# Staff Technical Position on Investigations to Identify Fault Displacement Hazards and Seismic Hazards at a Geologic Repository

**U.S. Nuclear Regulatory Commission**

Manuscript Completed: April 1992  
Date Published: July 1992

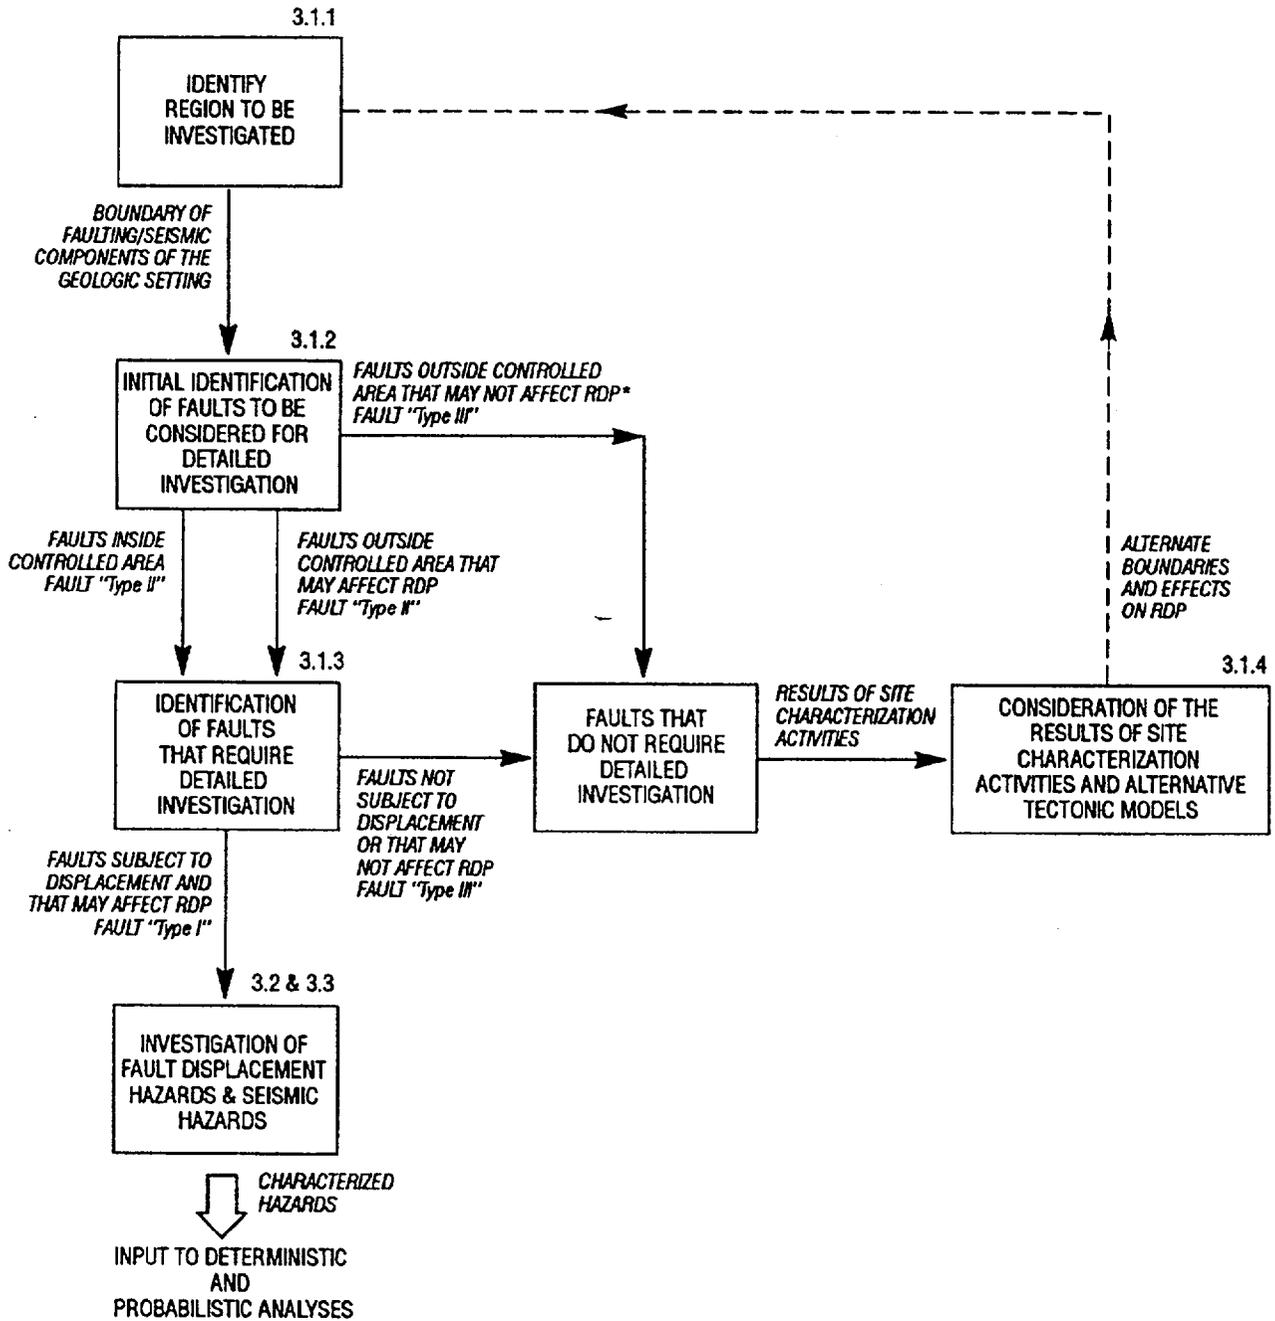
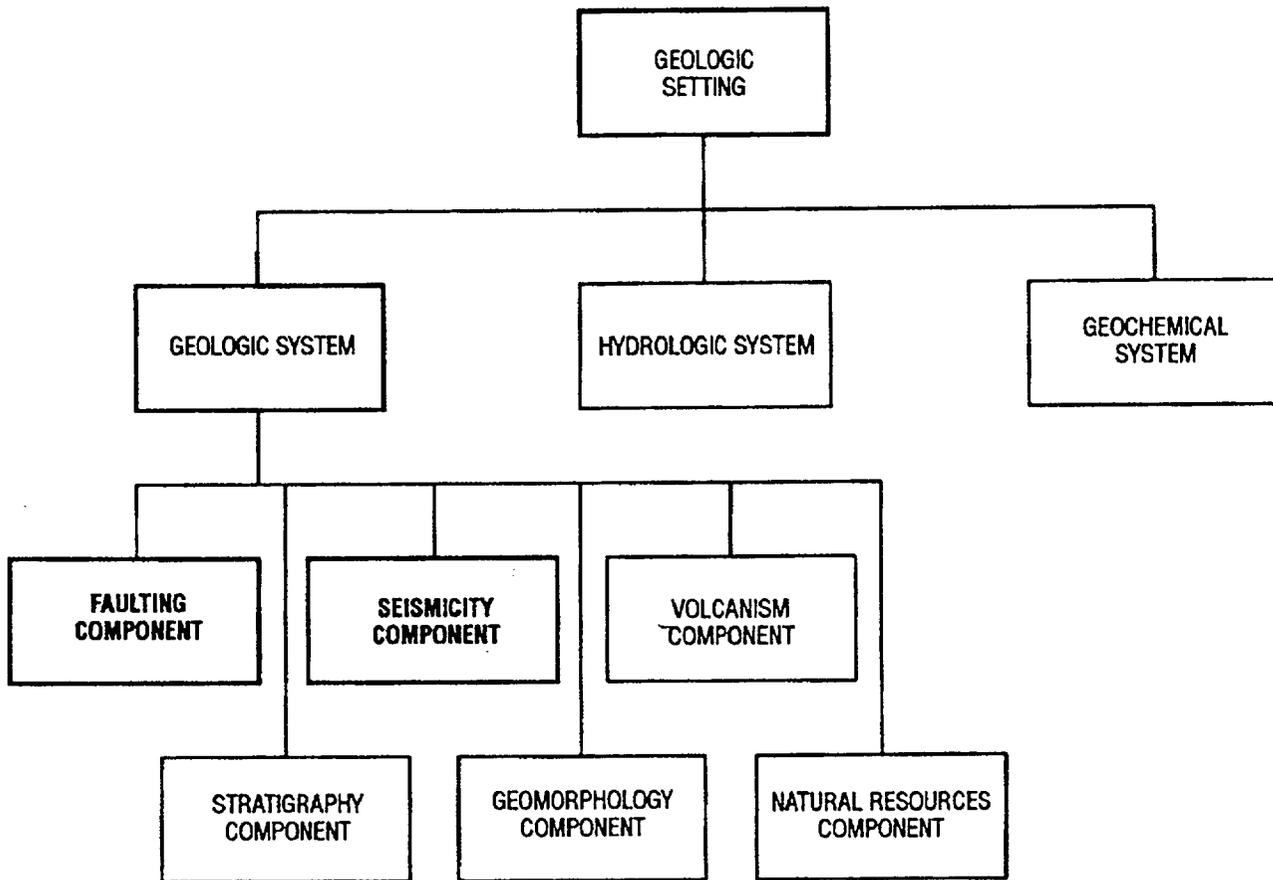
The STP should not preclude the use of probabilistic assessments of candidate faults lying outside the controlled area. A clarifying statement that a qualitative probabilistic performance assessment is acceptable should be added to the text accompanying Figure 1.

Figure 3 — Staff Technical Position 3.1.3: Detail to the "Approach to the Identification of Faults that Require Detailed Investigation (i.e., "Type I" Faults)". Refer to the text for the discussion of this two-step process. Also see Figure 1.

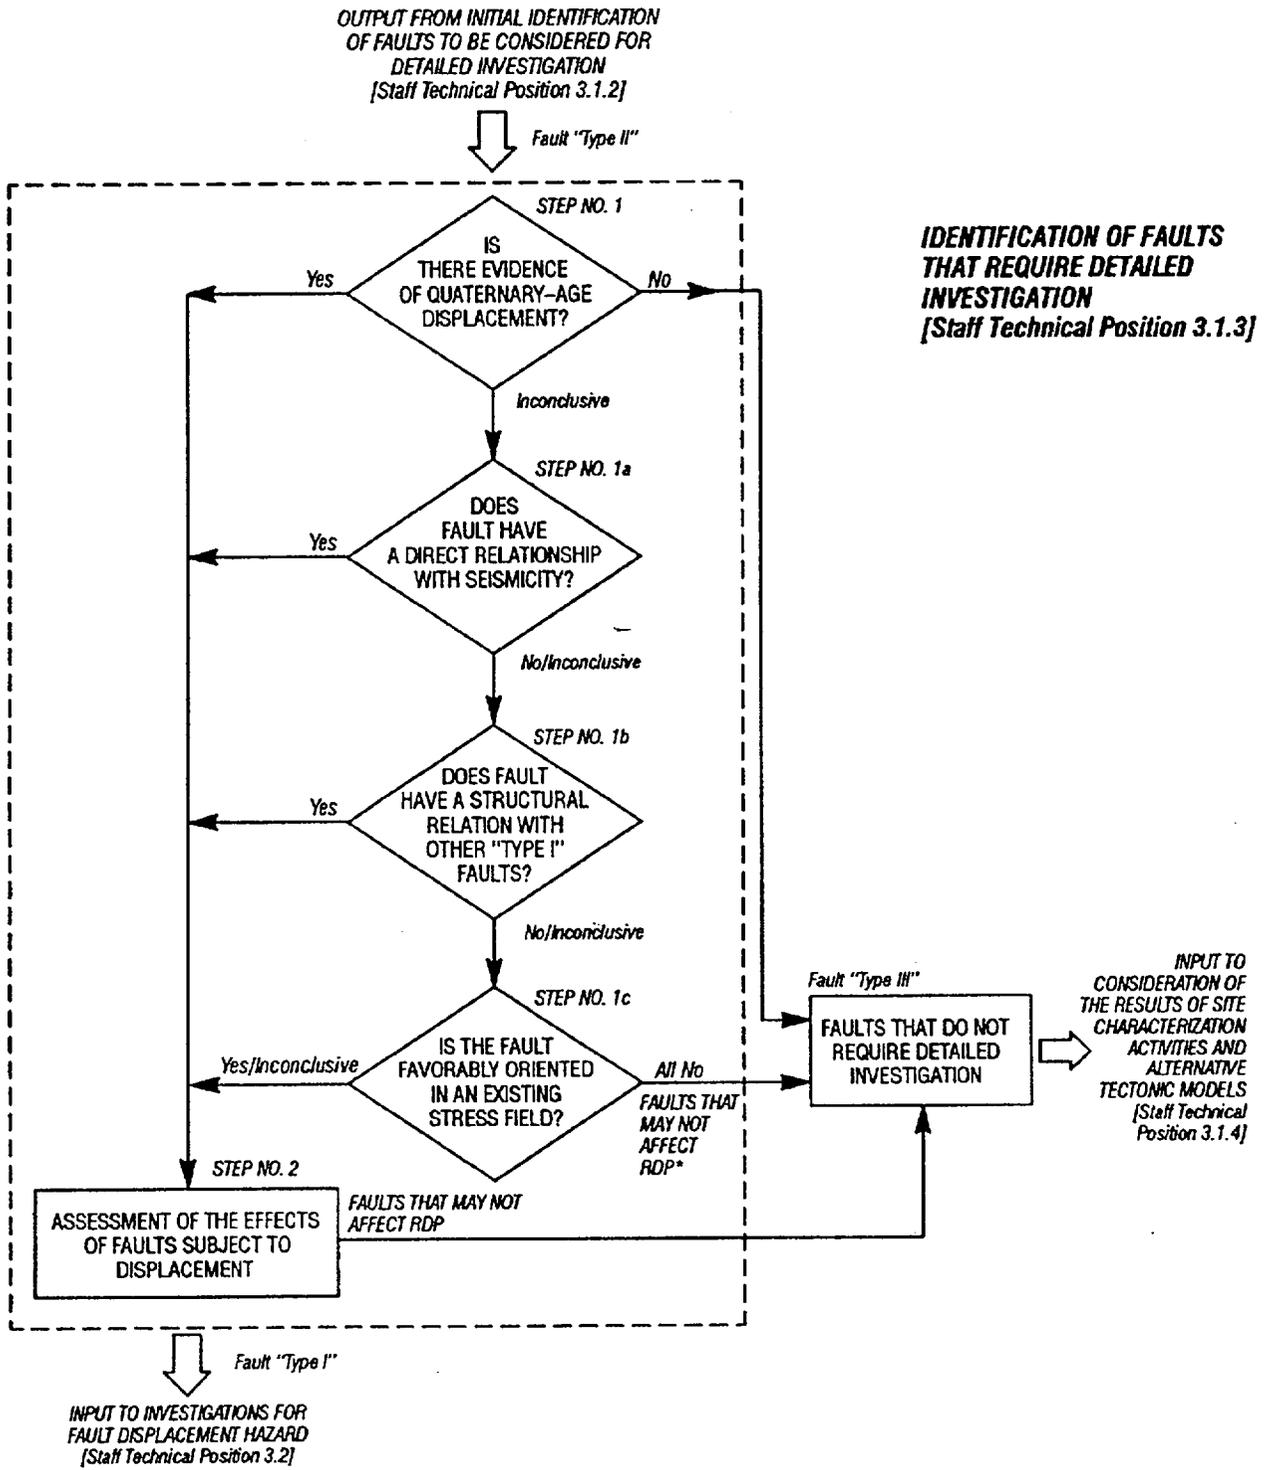
The staff should revise Figure 3 of the STP to indicate that only if Quaternary-age evidence is incomplete or unclear, should secondary criteria be evoked.

The staff agrees with this comment and has revised both the text and Figure 3, as suggested.
